# Gardens of Peace Muslim Cemetery

## Written Representation

Deadline 2

## Appendix 1.0 - Development Plan

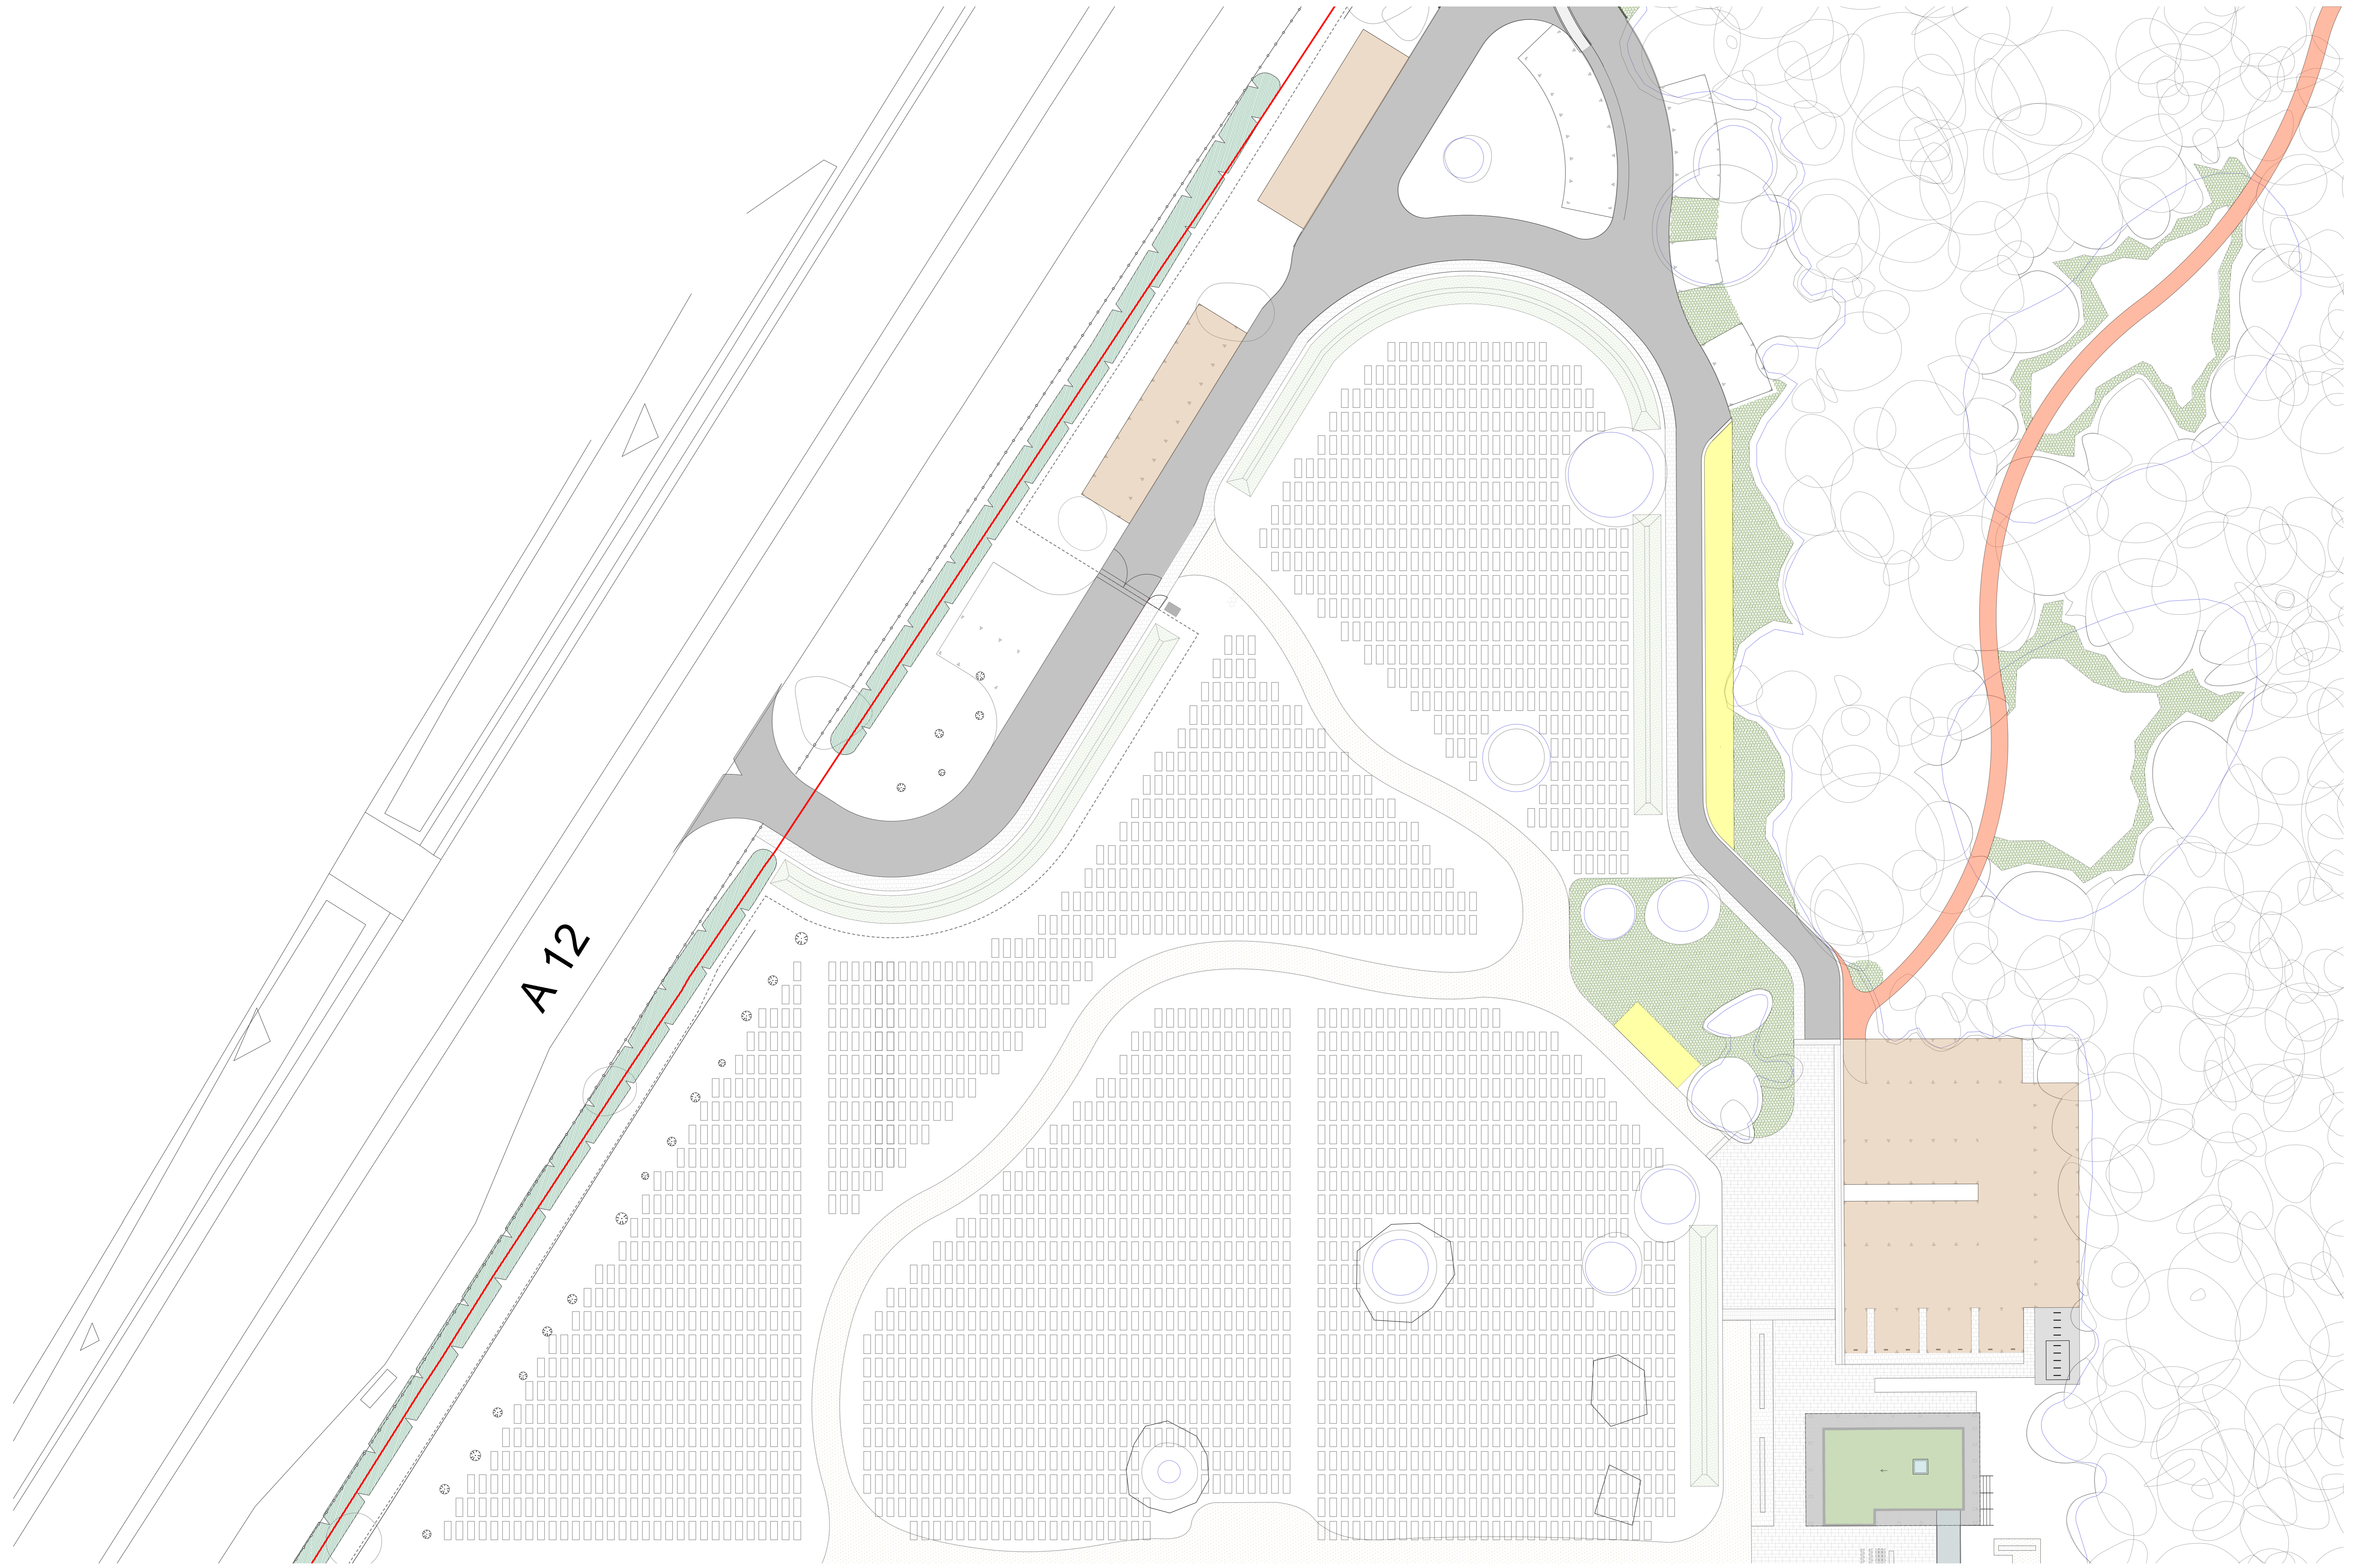
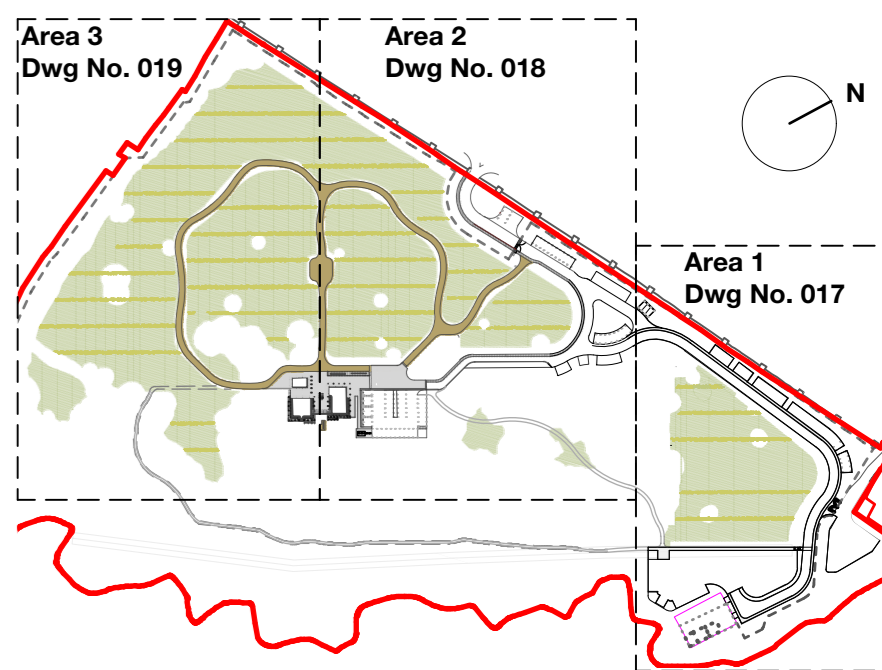
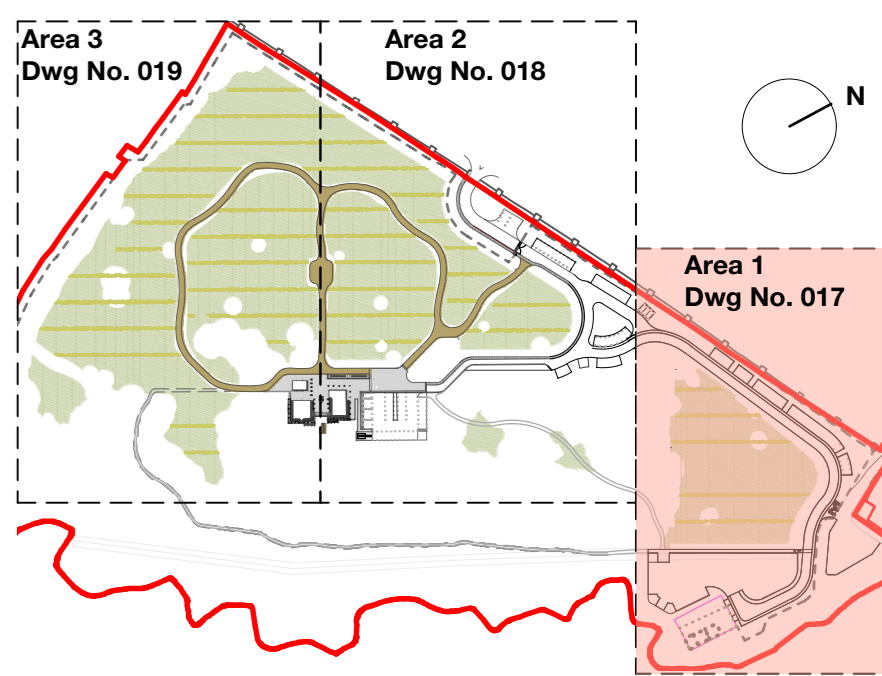
Gardens of Peace is a charity, and thus non-profit making, providing burials for the Muslim community in London. Gardens of Peace rely solely on Lillah (charitable) donations, burial and funeral fees to maintain the cemeteries, pay wages and to build a fund for future maintenance and development of cemetery land. Given the nature of cemeteries, Gardens of Peace is required to plan well in advance for future expansion. Accordingly, Gardens of Peace acquired 30 acres of land, Maylands, in 2007 to ensure it had a “land bank” for a new cemetery to serve the Muslim community once the existing cemetery neared capacity. Plot 1/8 forms part of Maylands. Gardens of Peace ownership is shown outlined red within the site plan at Appendix 1 (see Appendix 1 – Development Plan).

Due to the sensitive nature of the intended use of Maylands, the effects of the Scheme, whether temporary or permanent, are considerable and severe and the below mentioned issues are evident when taking into account the plans at Appendix 1 (Development Plan) and Appendix 4 (Plot 1/8 Overlay). We take this opportunity to outline these to you in detail;

Drawing Title:	<b>LAND PLANS REGULATION 5(2)(i) Sheet 1 of 4</b>	
Drawing Number:	<b>TR010029/APP/2.2</b>	Rev: <b>0</b>
HE PIN: HE551519	Scale: 1:2,500	Original Size: A1

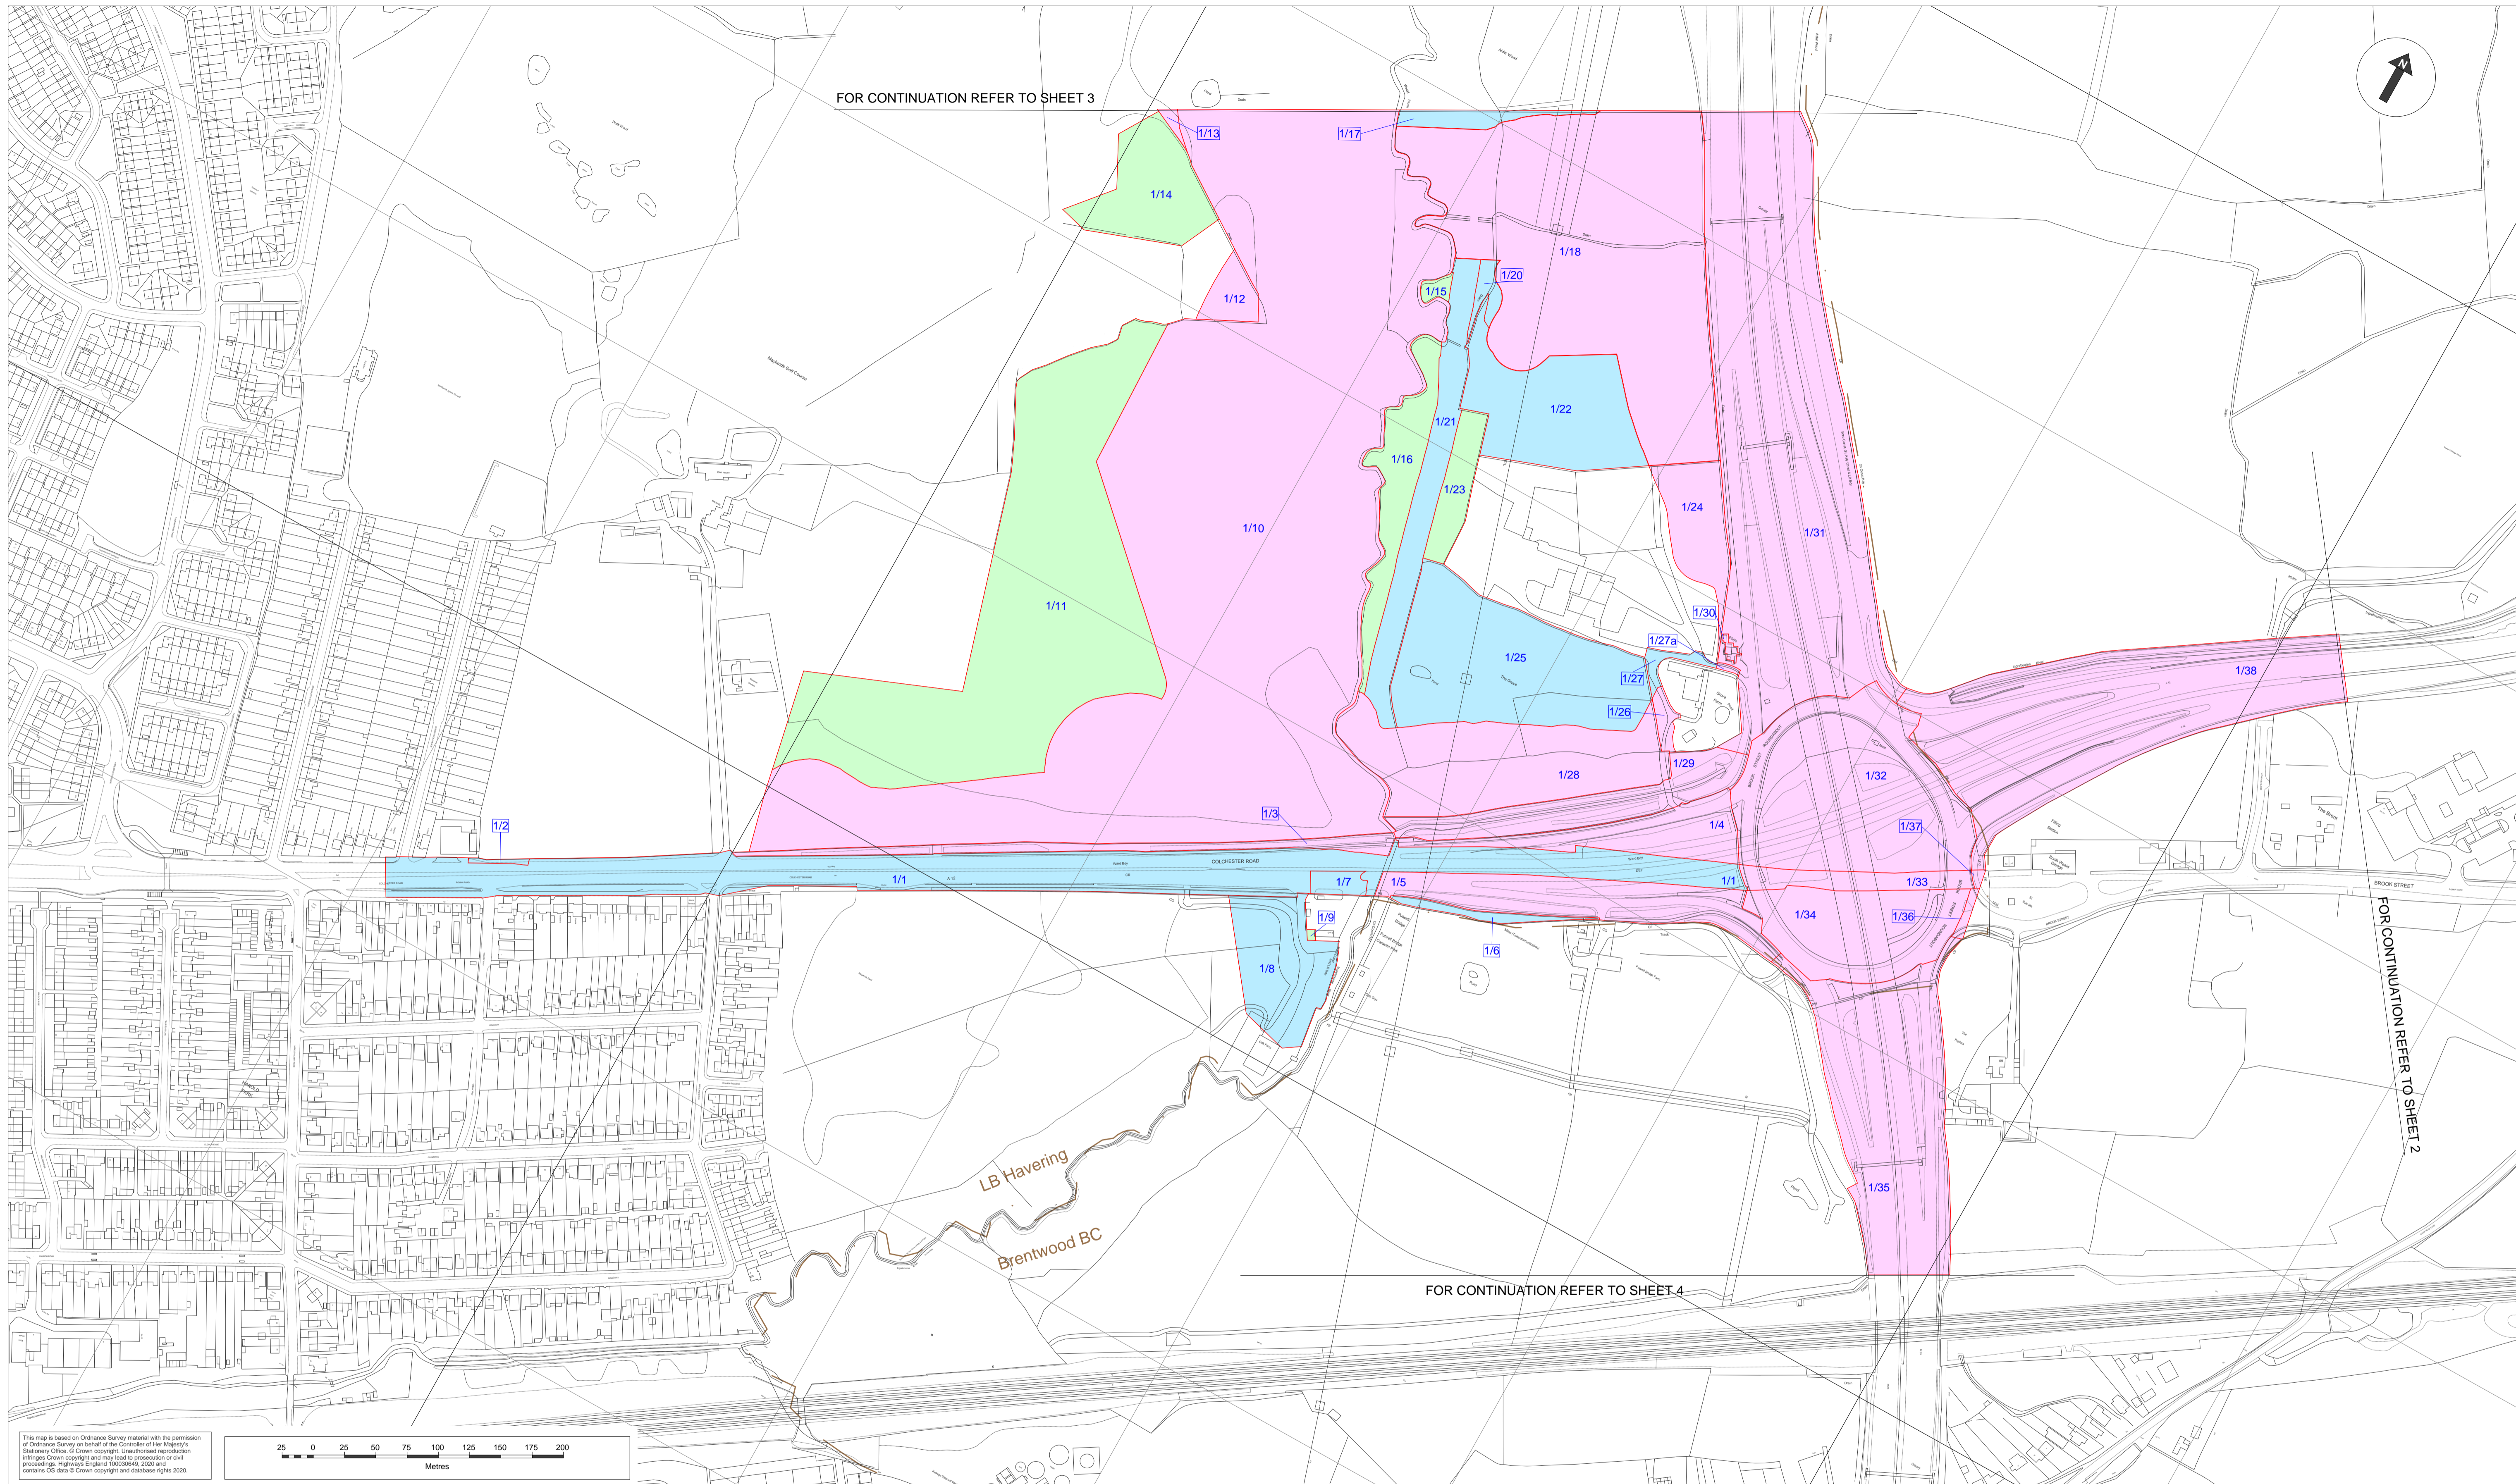
- Plot 1/8 of the Highways England M25 Junction 28 Improvement Scheme proposal (“the Scheme”), which falls within Maylands, is subject to the permanent acquisition of rights, thus likely to cause sterilisation of land which will be prepared for 512 burials. Not only will this will cause a significant loss of income to Gardens of Peace, but cause further pressure in meeting the needs of the Muslim community with a reduced number of burial plots.

The DCO application identified Plot 1/8, as per Drawing Number TR010029/APP/2.2 (see Appendix 2 – Land Plans – Plot 1/8), as an area that will be subject to acquisition of permanent rights. This is to allow for the installation of a high pressure gas pipeline. As per Drawing Number TR010029/APP/2.3 (see Appendix 3 – Work Plan), the proposed centre line of the gas main is shown as a broken orange line with the purple broken lines identify the limit of deviation for the gas main.
